Action Point	Response
6	Confirmation that Northumberland County Council (NCC) are satisfied with text in Art 7(b)(ix).	From a highways perspective, we are satisfied with the text as set out in Art 7(b)(ix)
7	NCC to respond to the Applicant's response to ExQ1 DCO.1.39 and DCO.1.40, in relation to Art 11.	The applicant's response to ExQ1 DCO.1.39 confirms that the revised DCO has consistency in notifying the Street Authority at 6 weeks and, as such, have no comments to make. (Noting DCO.1.40 is linked more to Article 12 so comments have been made on this under Point 8)
8	Applicant and NCC to consider Art 12 and identify any matters of disagreement.	Following on from our meeting with the applicant on 15th February, the applicant's consultant has shared notes of the meeting on 10th March, which have provided clarity in relation to Article 12, along with the points of clarity made in the Hearing Sessions. It is understood that these notes will form subsequent iterations of the Statements of Common Ground to which we will comment and confirm.

Response to Point 36

Figure 36.1 Extract from TADU ATC Traffic Speeds Dashboard (Source: TADU 2018)

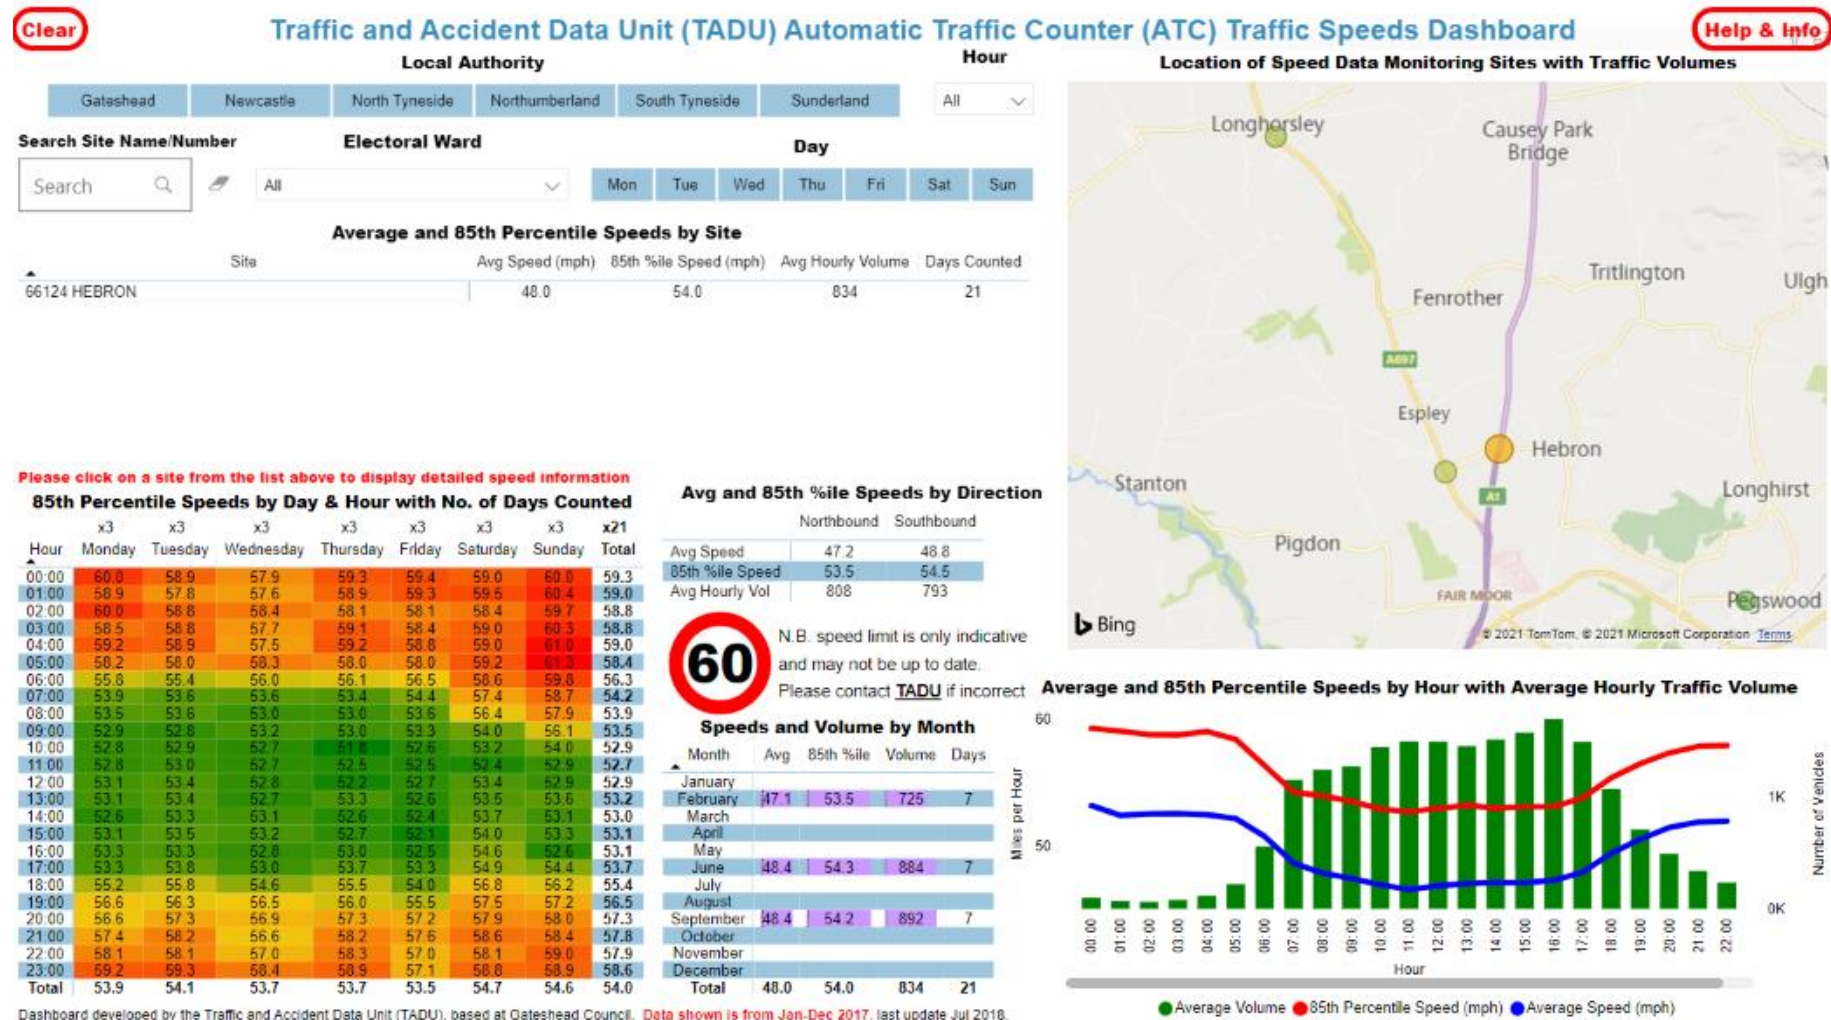
Analysis of these flows indicate an 83% reduction on the 2020 figures and 87% reduction on the 2019 figures on the busiest section (Fenrother to Earsdon). The reduction in traffic flows will lead to an increase in traffic speeds. Figure 36.1 below shows the 2017 traffic speeds at Hebron on the A1. Although showing hourly figures for volume of traffic, the graph (bottom right) shows how speed increases as traffic flows drop. Based on this we would predict at least a 5mph increase in the 85th percentile speed on the de-trunked section as a result of the reduction in traffic flows.

The current WS2 standard road width combined with a good horizontal and vertical alignment and good forward visibility will also contribute to potential further increases in traffic speeds.

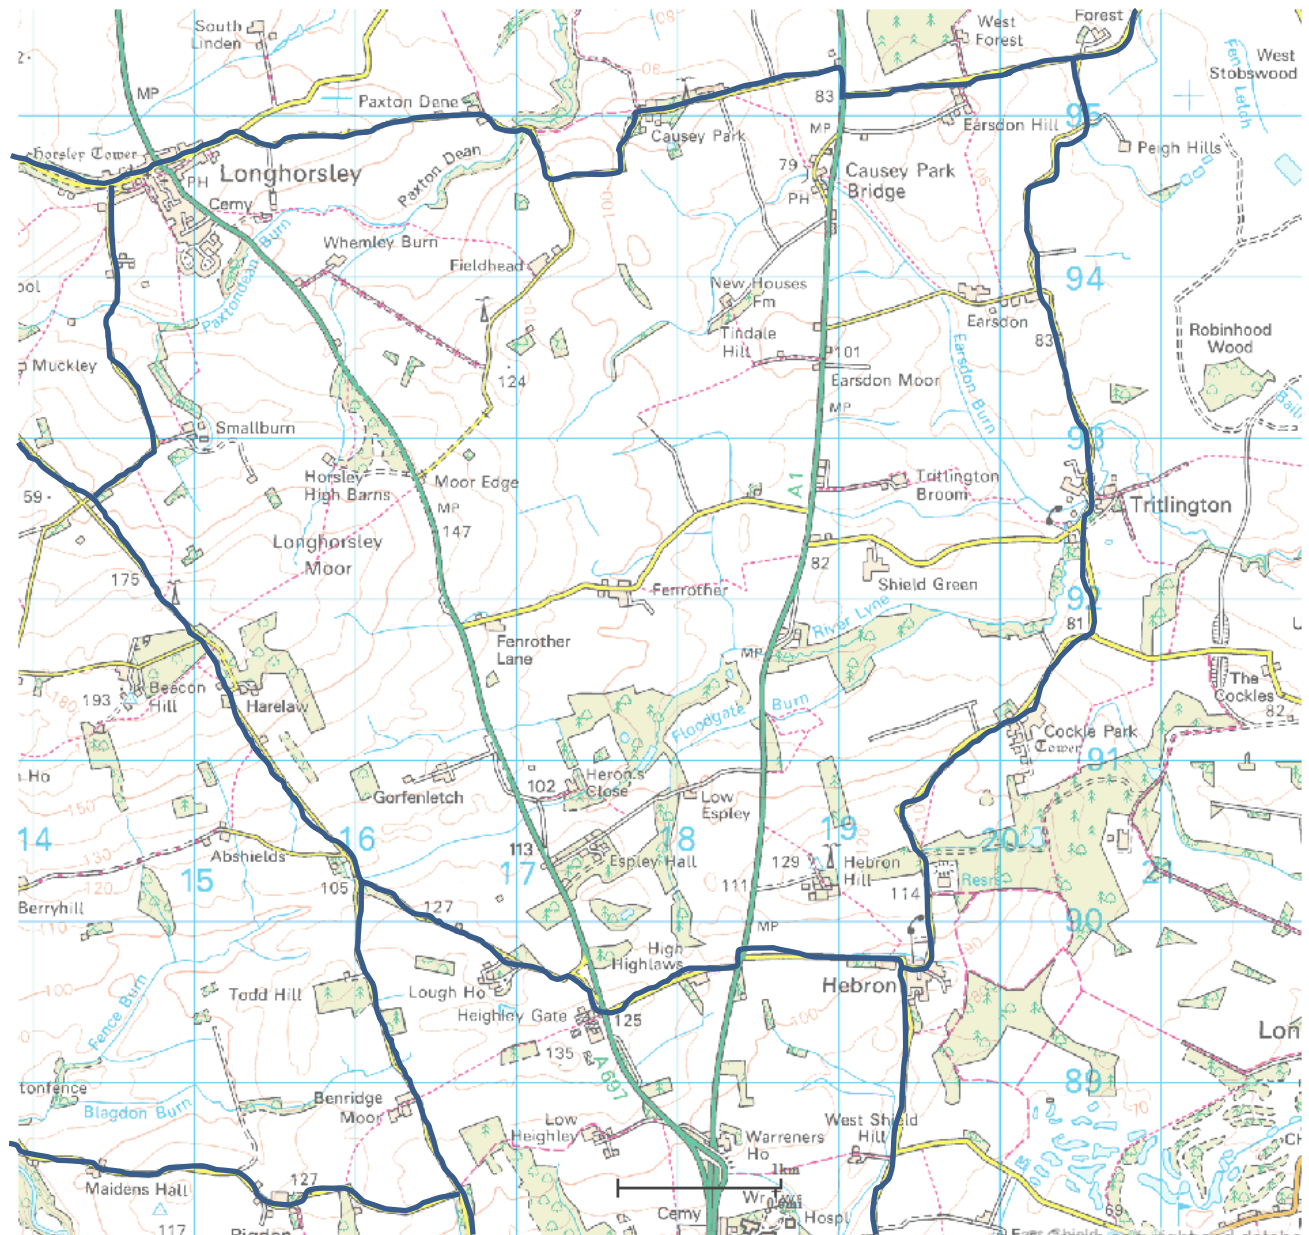
In respect to the above assessment, the scheme will result in a reduction in traffic flows on the de-trunked A1 meaning that the existing cross section of the carriageway will be unsuitable and unsafe as highlighted in the Stage 1 Road Safety Audit. In amending the cross section of the de-trunked A1 to better reflect traffic volume and reduce speed, the opportunity arises to provide non-motorised transport links in a north-south direction connecting the east-west routes that have been mitigated through the scheme as it currently stands. It is considered that there is sufficient space within the cross section to provide an LTN 1/20 compliant scheme on the de-trunked section.

Cycle Routes in the Vicinity of the A1 between Morpeth and Felton

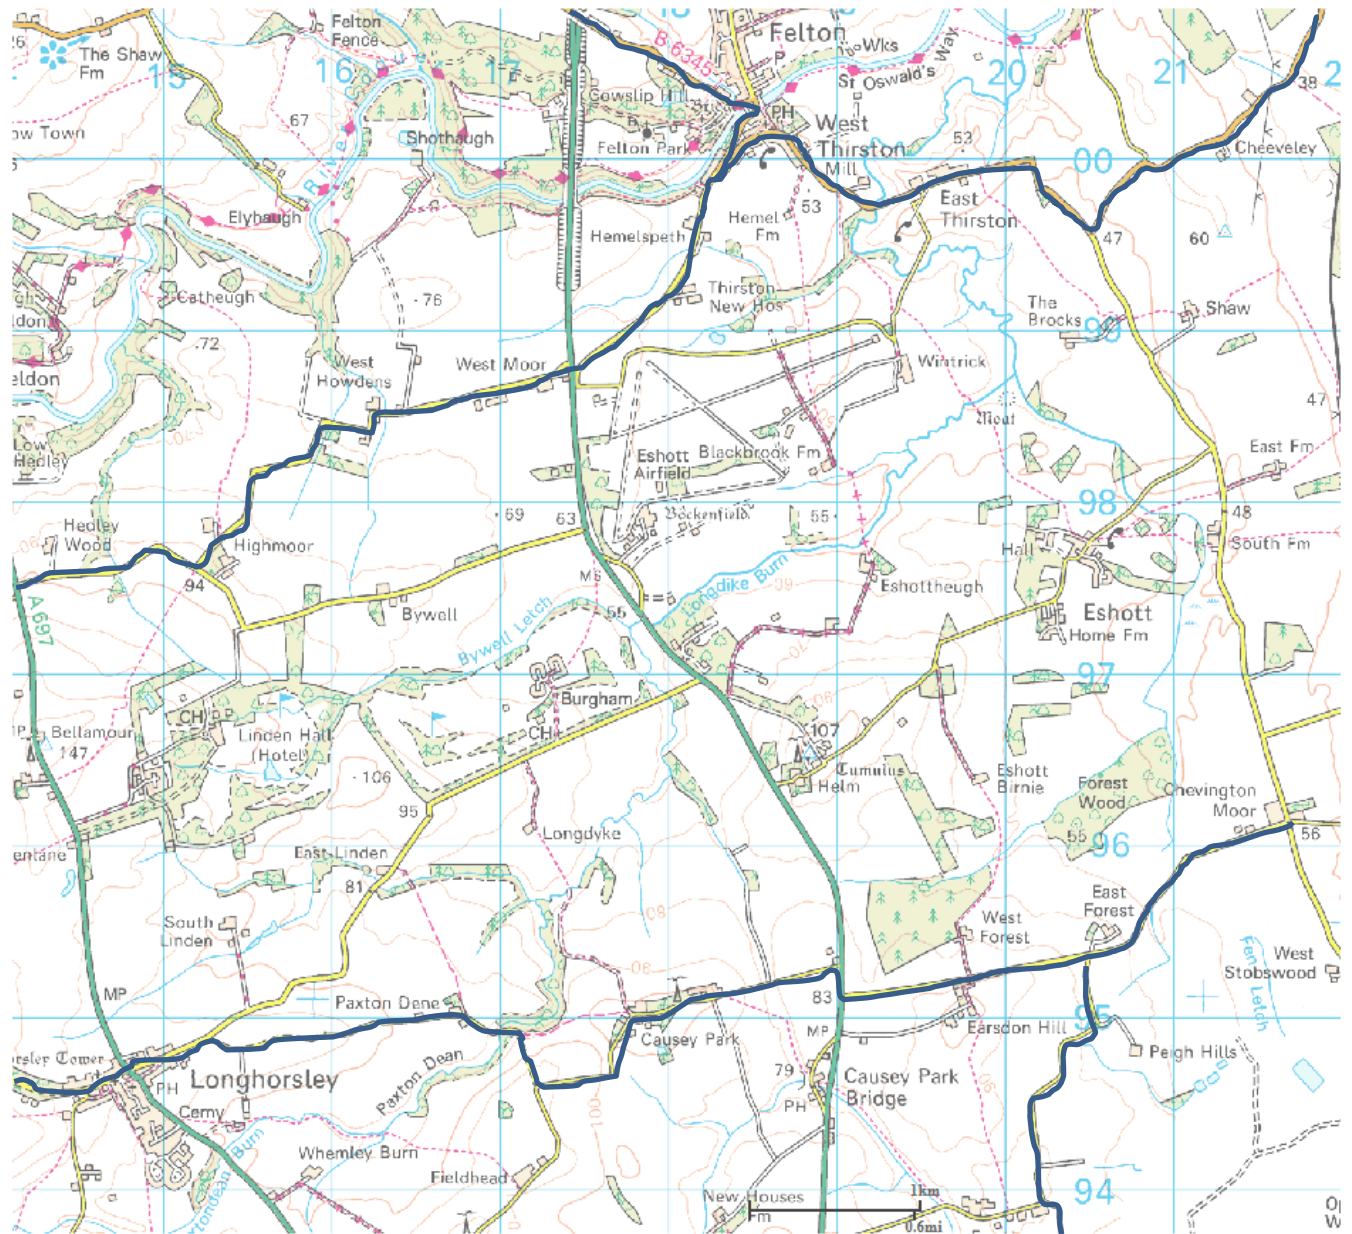
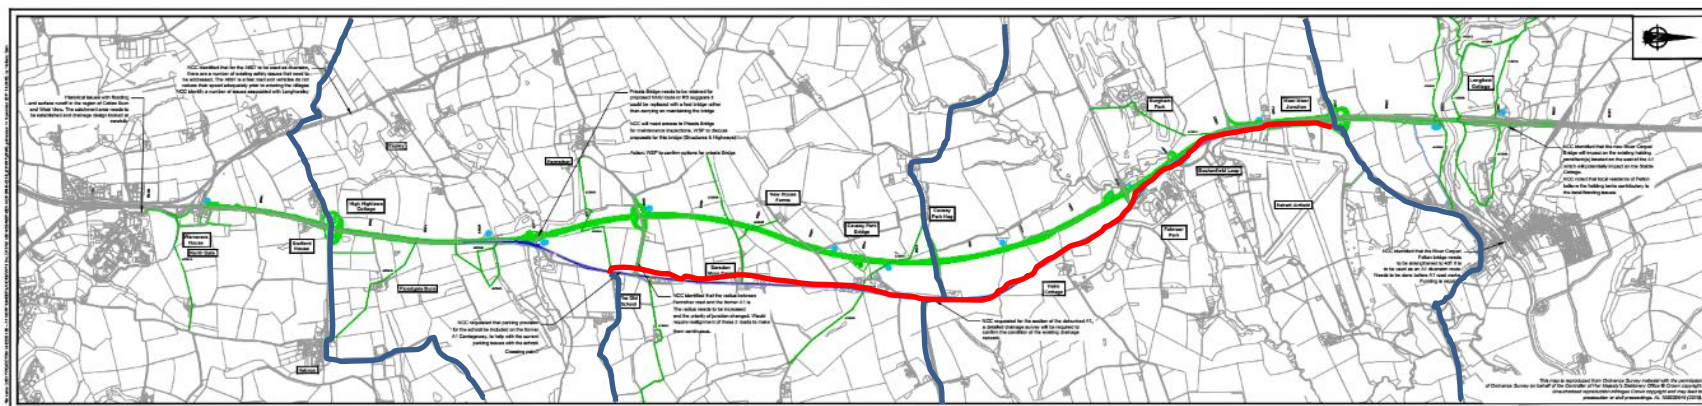
Accepting that this treatment of the de-trunked A1 and the new link from West Moor to Brockenfield Bridge is to be delivered, there will remain a further section of north-south severance from the end of the de-trunked A1 at Priest's Bridge to the current cycle and pedestrian infrastructure in Morpeth. It is considered that this severance can be addressed within the land under the DCO subject to some minor amendments in relation to the designation of the diverted Public Rights of Way and the improvement of the existing footway on the eastern side of the A1 that is currently shown as being retained.

Working south from Priest's Bridge (referencing points in the Rights of Way and Access Plans) this would require the re-designation of the proposed New Public Footpath from points PR3/3 to PR3/2 and PR3/1 to PR2/1 and the section of existing Public Footpath PROW407/002 between PR3/2 and PR3/1 to Public Bridleway with changes to surfacing to accommodate cycle based trips accordingly as part of the detailed design. Alternatively, there may be the opportunity to allow this link to continue adjacent to the widened A1 to the east of the on-line alignment but an alternative route is possible if this is not deliverable adjacent to the new dual carriageway. South of Hebron Road at Highlaws Junction, the current intention is for the existing footway to be retained and therefore this could be upgraded to footway/cycleway to connect with the new Public Bridleway to the south of Warreners House to connect with West View. This connection can be delivered within the scheme extents potentially within the assumed limits of highway adoption around the A697 southbound on-slip embankment. There would be potential highway safety and severance concerns if this link was not aligned to avoid at at-grade crossing the A697 southbound on-slip at the location of the existing footway crossing located to the south of 1/g on the Rights of Way and Access Plans.
